Product / Process Change Notification (PCN)

PCN #: PCN_IndGFH_20210201
Affected Series: WE-GFH; 7447649xxx; 7447669xxx
PCN Date: November 16, 2020
Effective Date: February 01, 2021

Reflow Profile:

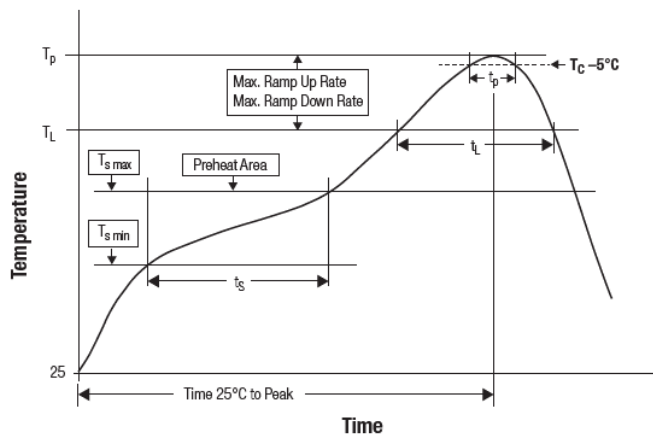
The samples are tested with a peak temperature at the reflow soldering of 250°C according to IPC/ JEDEC J-STD-020E.

Classification Reflow Profile for SMT components:

will change to
